**Re: Cold Brook Crossing
Stormwater Management Peer Review
Response to Comments**

Civil Design Group, LLC (CDG) is in receipt of The Horsley Witten Group's (HW's) review letter, dated April 17, 2020, for the above-referenced project. Our responses are provided below in **bold** following each of HW's comments, and supporting plans and documents are enclosed herein:

SHEET:
BMP PLAN
FIGURE 1A

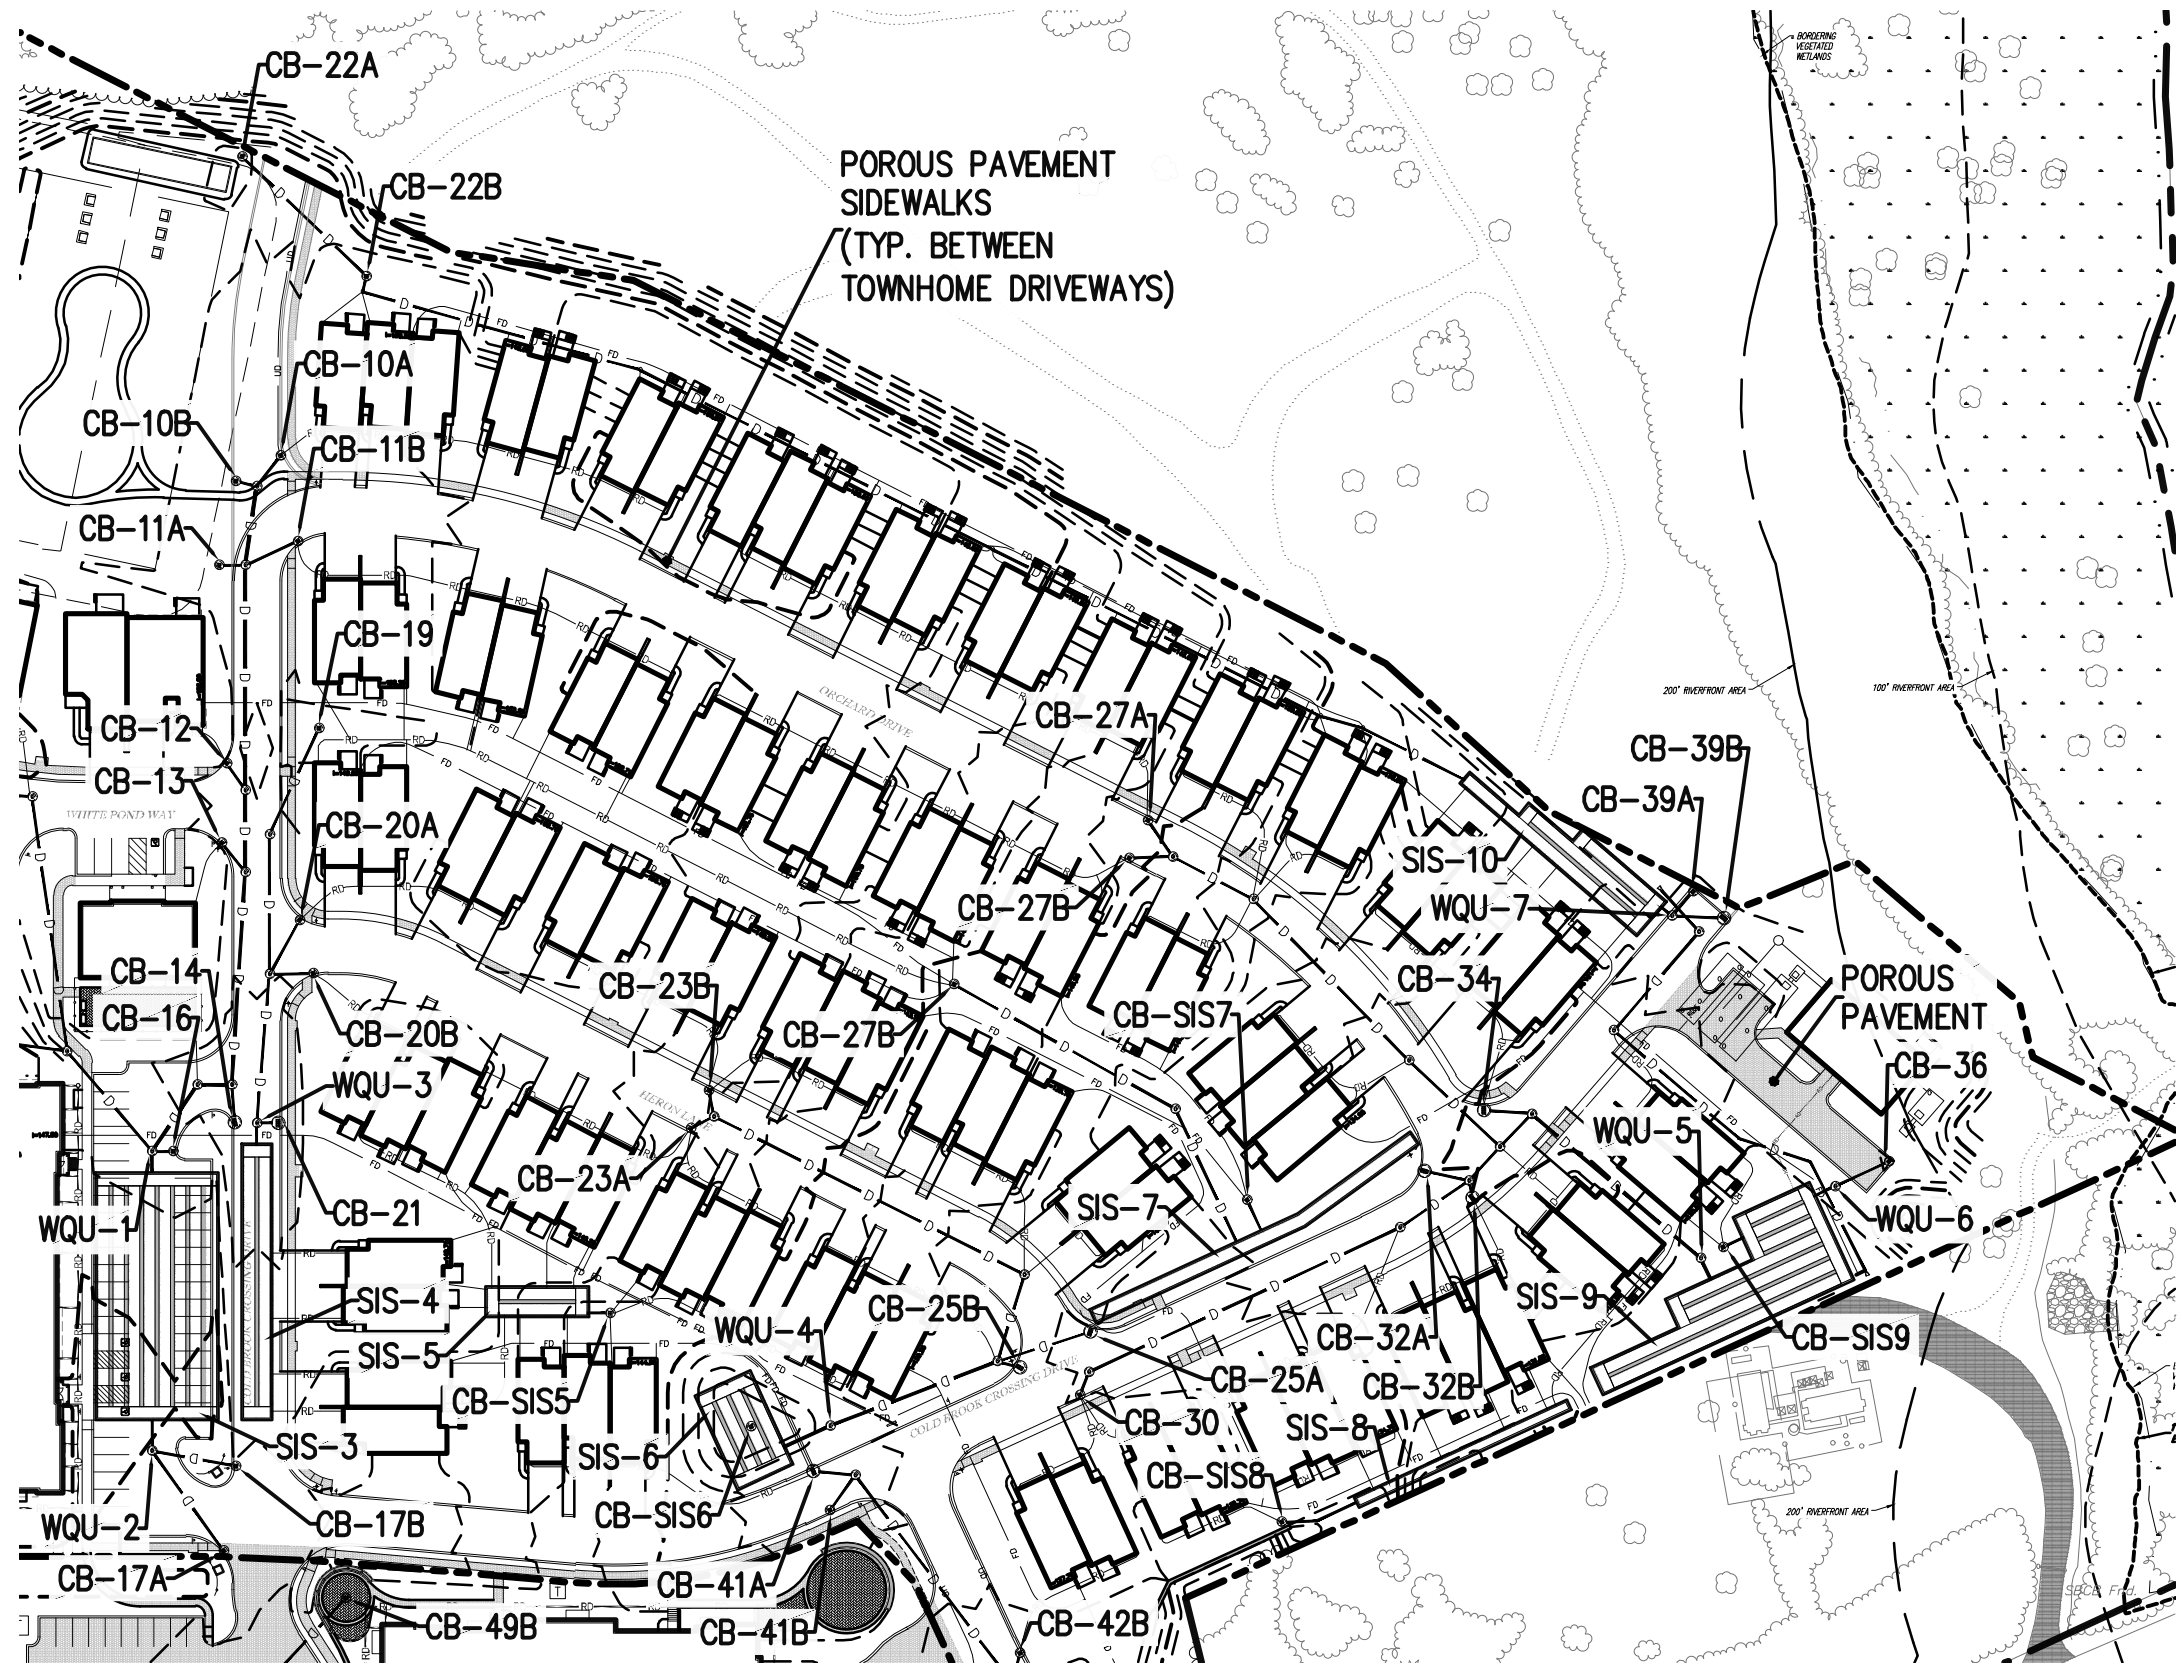
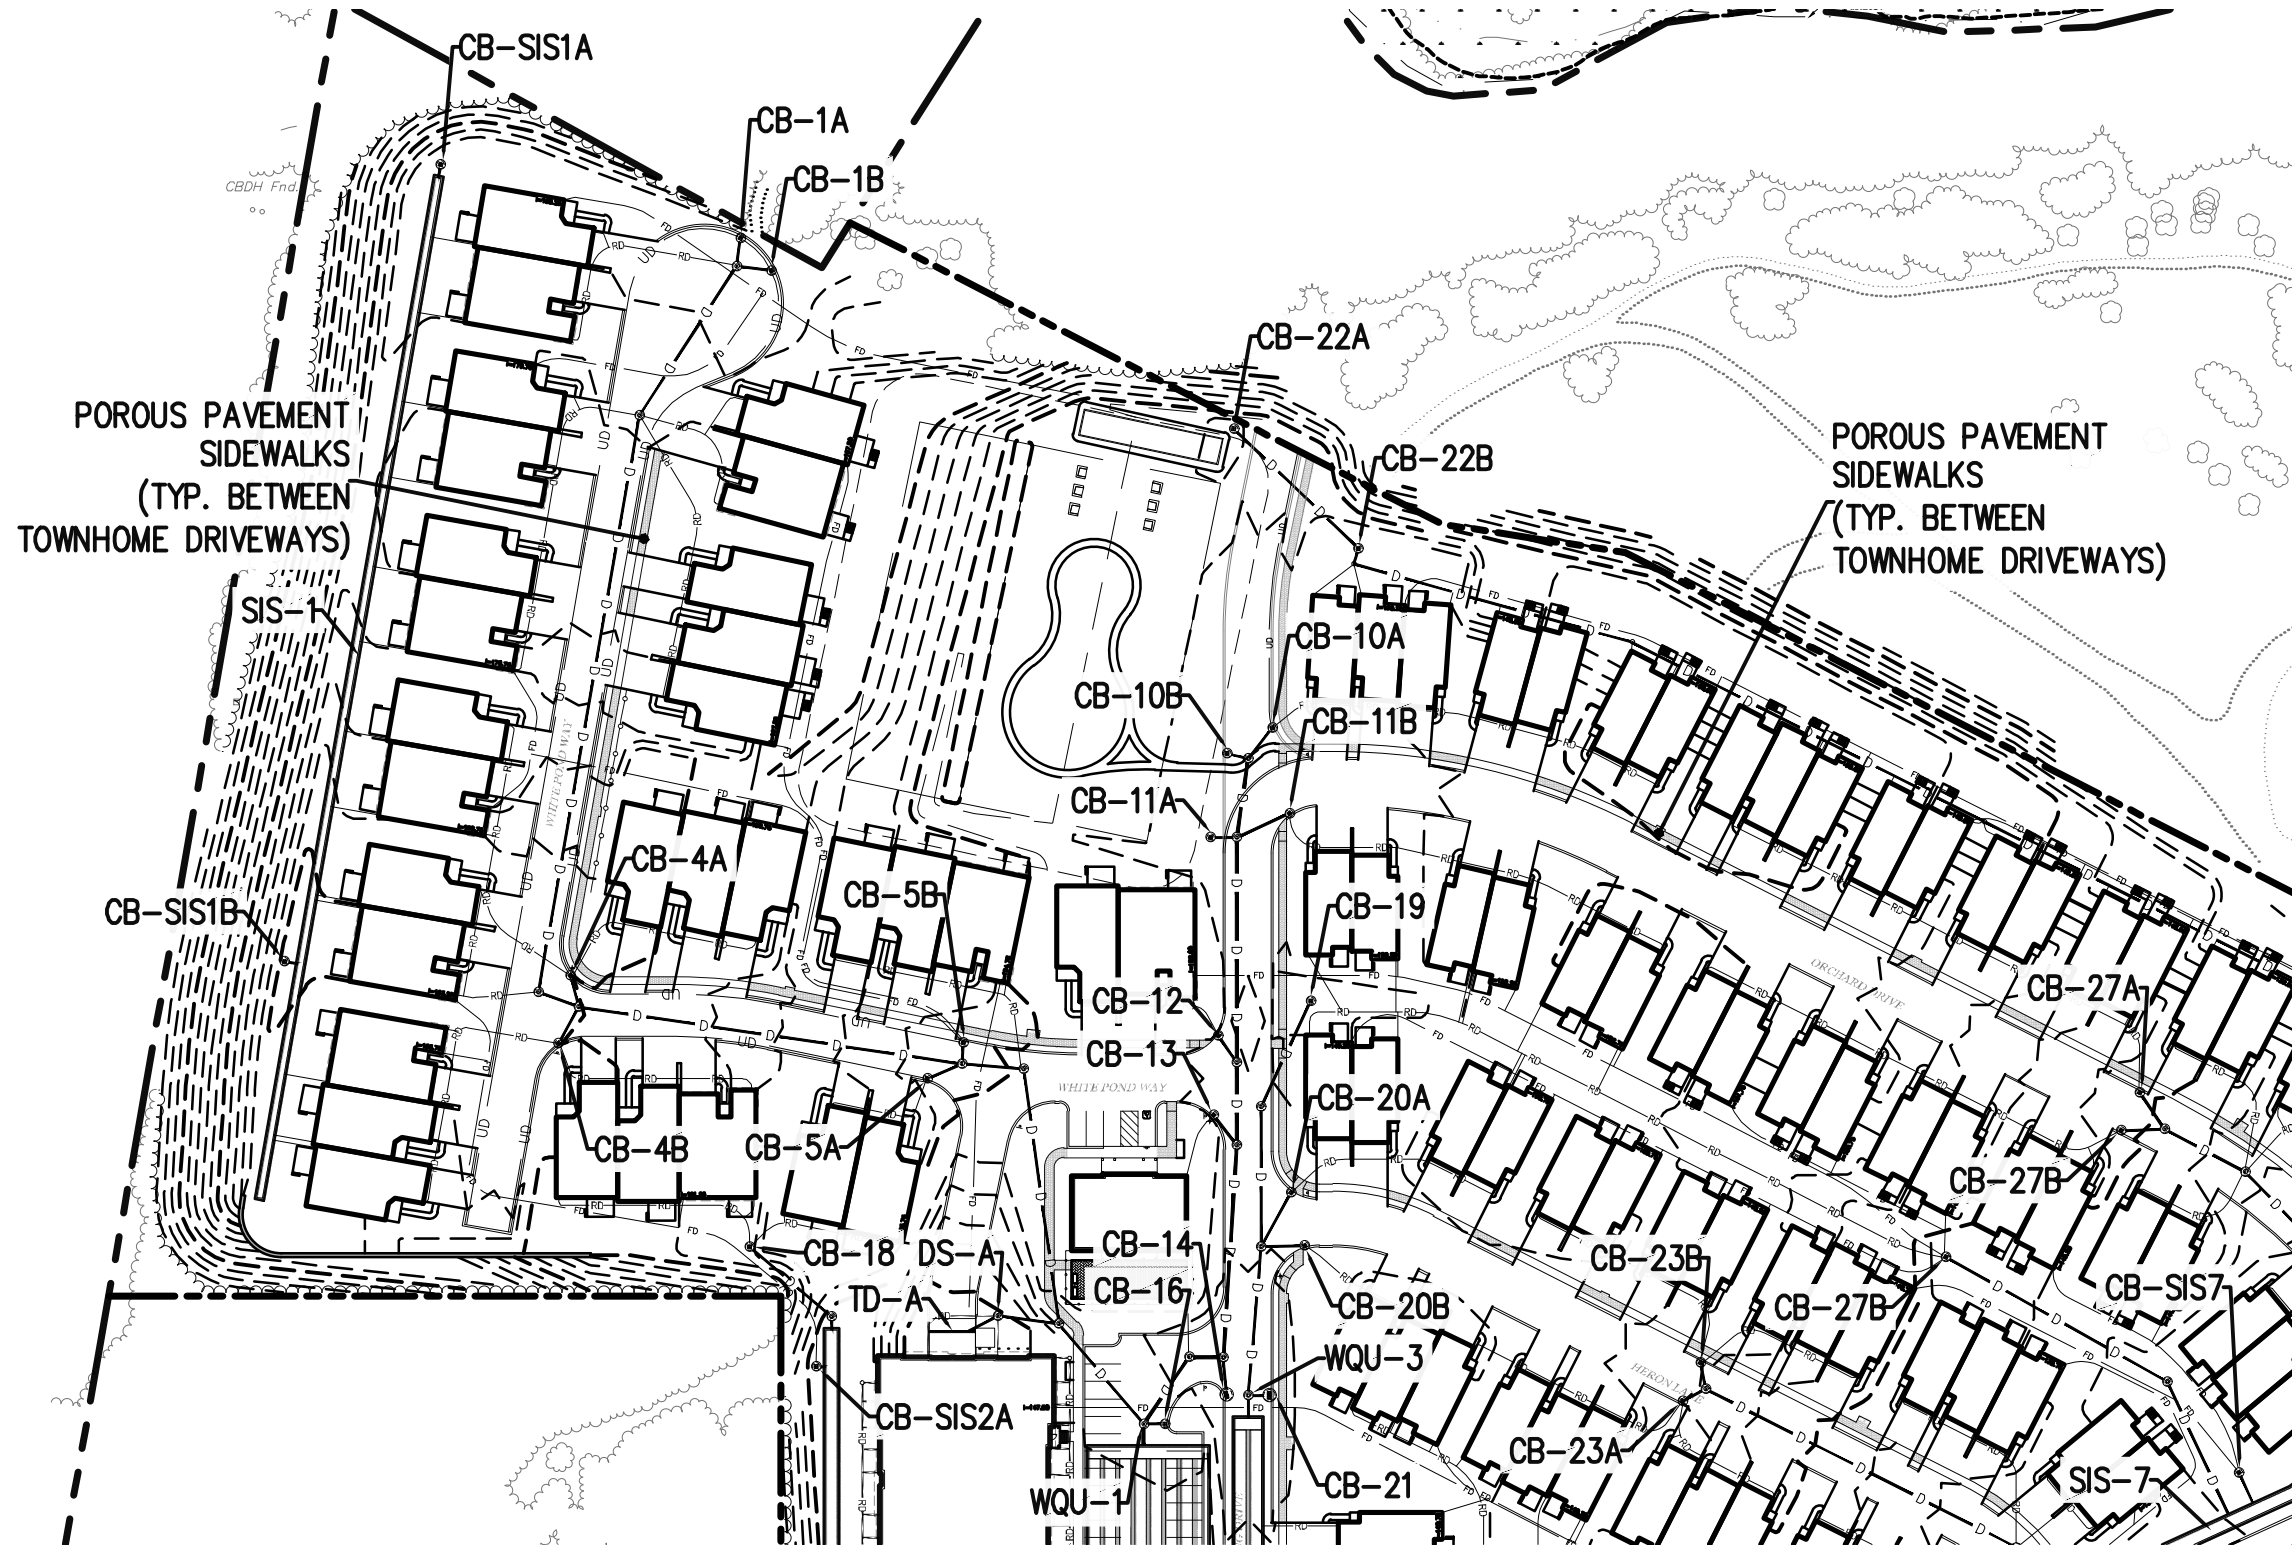
- b. HW recommends that the Applicant provide a simple stormwater practice location map as part of the Long Term O&M Plan.

As requested, a *BMP Plan* has been added to the O&M plan to show the locations of the various BMPs referenced in the O&M plan. A copy of the updated O&M plan including the *BMP Plan* is included as Attachment 6.
